## Objection to planning application HGY/2023/3298 for a new dwelling on Land rear of 168 Muswell Hill Road N10 3NG

On behalf of: Residents of Muswell Hill Road and Church Crescent

Prepared by: Steve Miller Dip TP MRTPI

Date: 14/05/2024

## Loss of outlook and adverse impacts on trees at 170 Muswell Hill Road

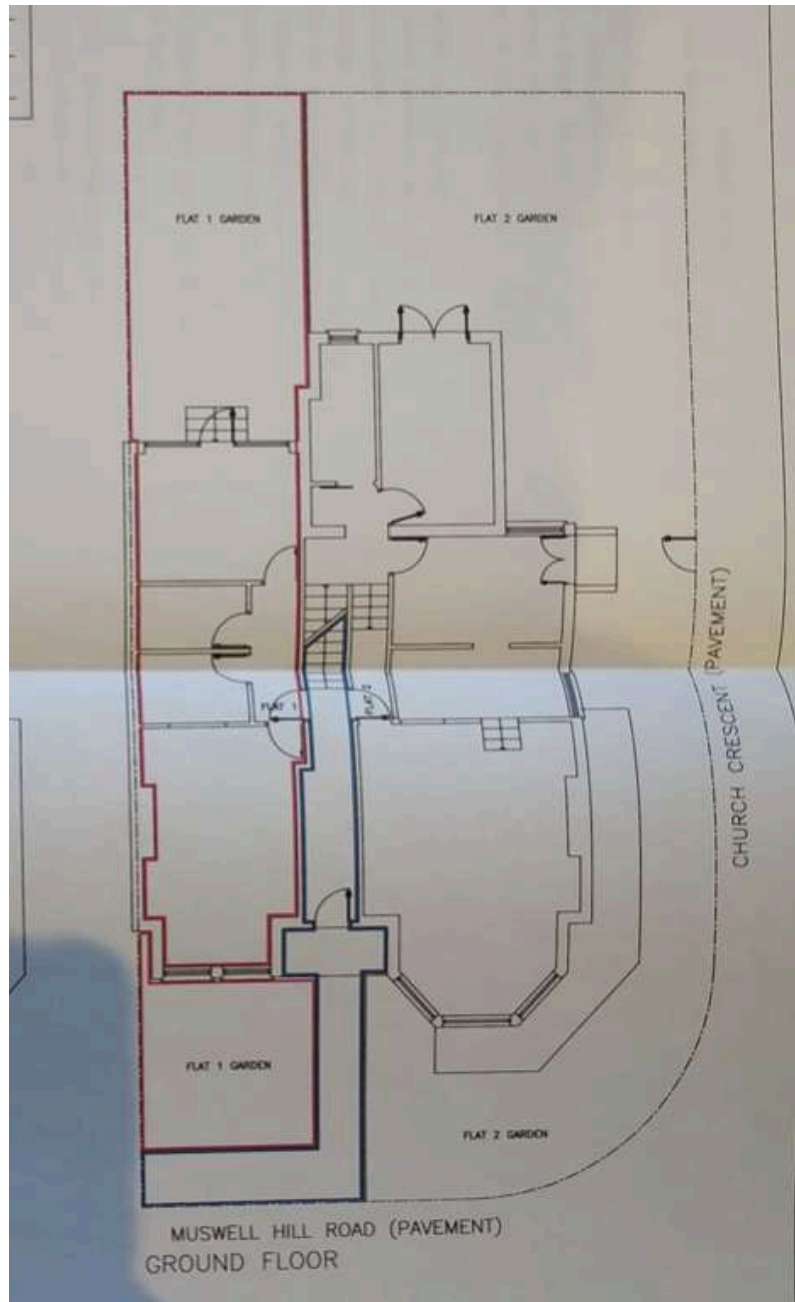
As stated, the hornbeam and sorbus trees in the garden of 168 next to the site boundary would likely be destroyed by the development. The result would be unfiltered views of the new house within 5m of French doors from the principal habitable room at ground floors. This would be very obtrusive, contrary to DM7. The zinc cladding proposed would also be garish and out of keeping also.

## First floor and loft floor 168 Muswell Hill Road

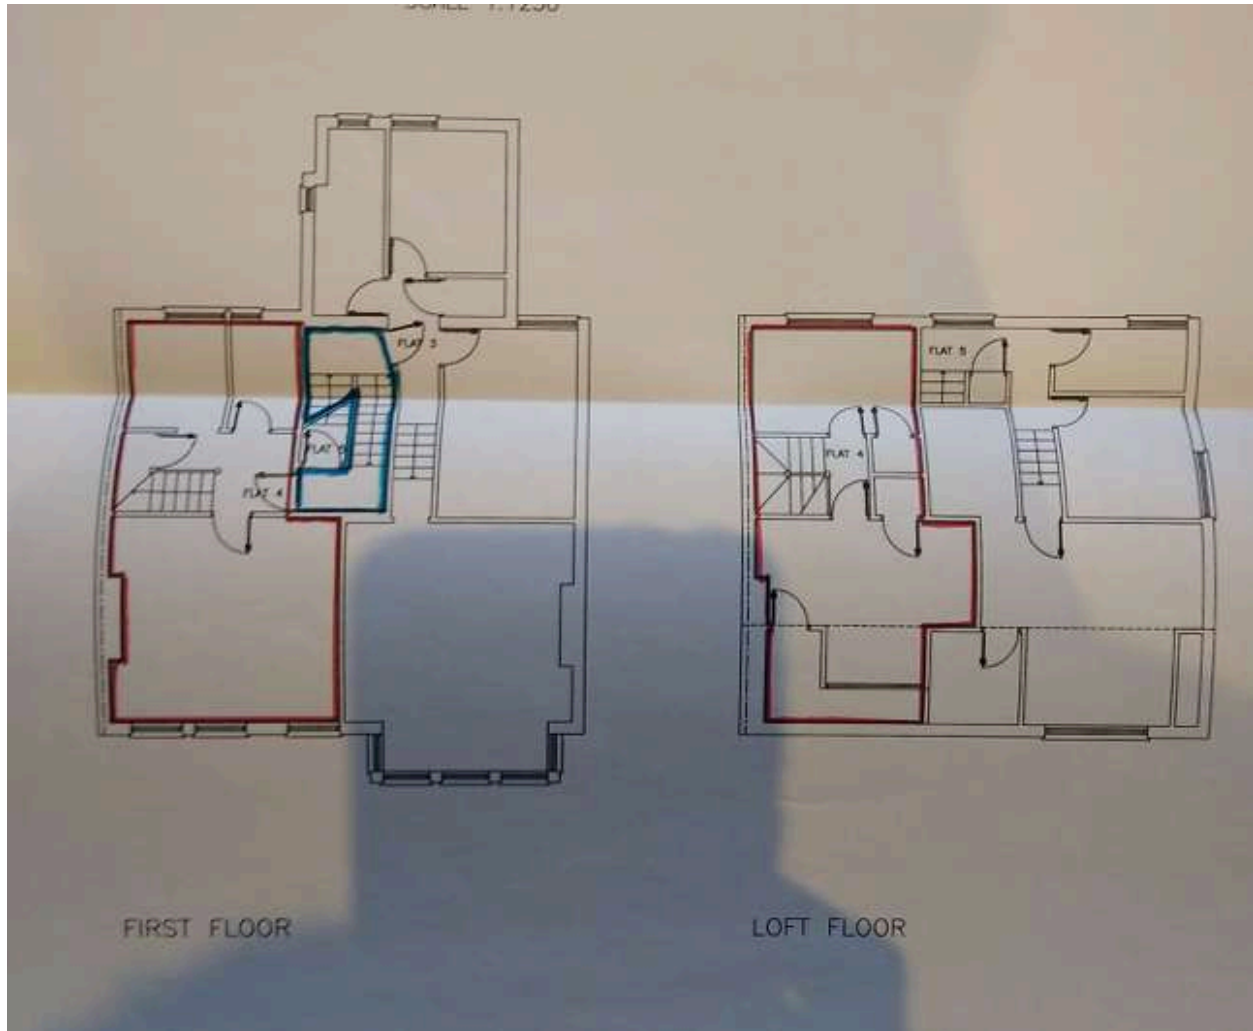
168 comprises 5 flats and the private garden area next to the site is a precious amenity for residents. At present this has an open character eastern outlook with trees. The proposals would hem in the garden making it claustrophobic and the loss of trees would further degrade its value contrary to DM1 and DM21. Flat 1 is already hemmed in south side because of an extension thus reducing sunlight overall. The proposals would further degrade this important amenity. Overshadowing of the garden would occur from

#### **Right hand outlook**

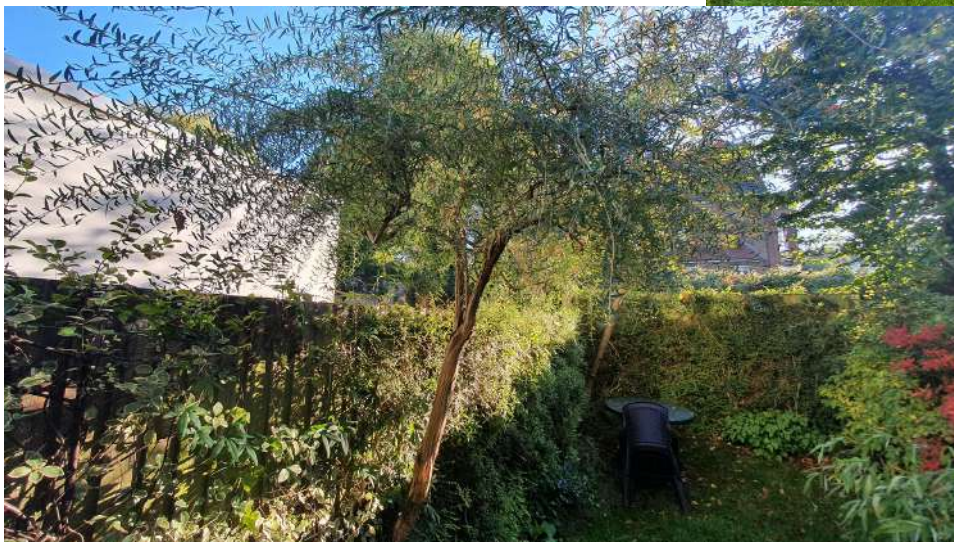
It will be seen how much Flat 1 is hemmed by the flanking projections, as below. It is narrow with a narrow garden extending to the application site. The rear aspect is already constrained by the rear projection on flat 2 and 170 creating a tunnel effect. This makes the remaining open aspect over the site even more important. The outlook from the rear habitable room is shown on the photos below. The proposals would have a cramping effect and the natural outlook would change from being natural to a two storey zinc box . Sue Czapska the resident of this flat has serious medical illness and has also lost mobility in the last year due to spinal arthritis, stenosis and impingement on nerves. It is now very difficult for her to leave the flat. She therefore relies on existing amenities, including the green setting and the garden she has created over 44 years. She would also be unable to get away from her flat during construction noise. Construction noise including excavation close to the boundary and the claustrophobic effect of this crammed in house will be very difficult for Sue to bear.

## Rear aspect of 168 Muswell Hill Road

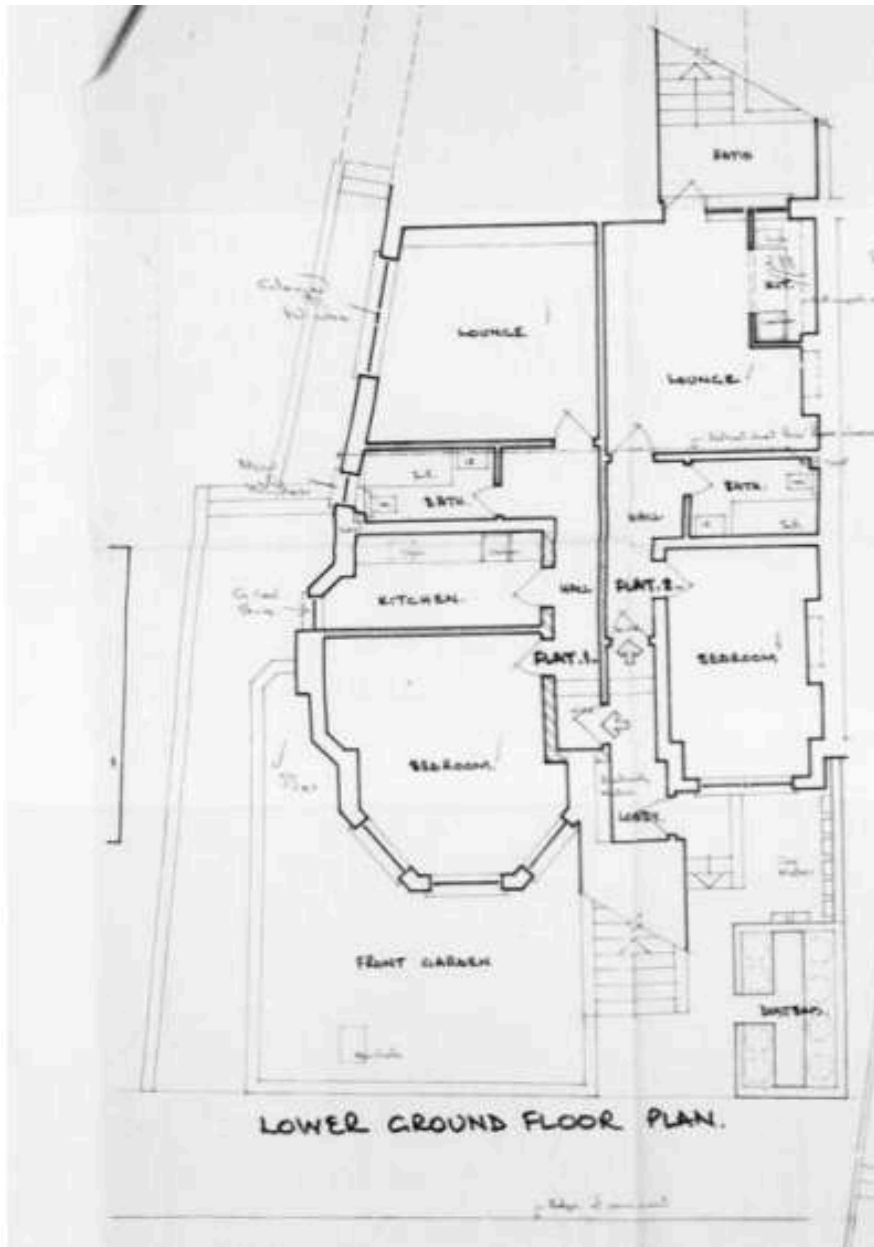
The proposals would therefore fail to achieve a place with high standards of amenity for existing residents, as is required by NPPF para 35 and DM7

**Kitchen Flat 1**

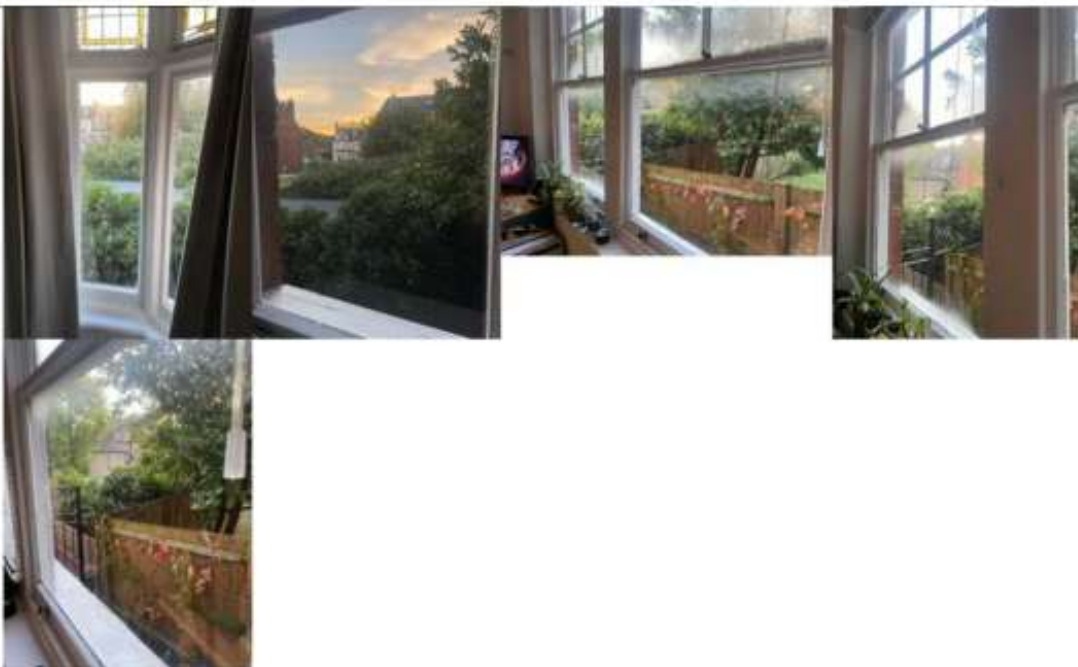
The lower ground floor flat 1 contains numerous windows facing the application site which would be severely impacted by the new dwelling, including a bedroom and kitchen. The sole kitchen aspect faces the proposed 2 storey part of the new house. The kitchen faces south and would be affected by loss of afternoon sun. Kitchen windows are important as noted in para 2.1.13 of the BRE Guide which states *Living rooms and kitchens need more daylight than bedrooms, so where there is a choice it is best to site the living room or kitchen away from obstructions*. The layout of Flat 1 is shown below-

All of these would be affected to a greater or lesser degree by the proposals. The south outlook would be severely impacted by the zinc “box”. No lighting analysis has been provided. The house would likely affect daylight into 168 habitable room windows because it would subtend the 25 degree angle ( para 2.2.5 of *BRE Site Layout Planning for Daylight and Sunlight*). Para 2.2.5 states that *If for any part of the new development this angle is more than 25 degrees a more detailed check is needed to find the loss of skylight to the existing building*. The 25degree angle would be blatantly compromised
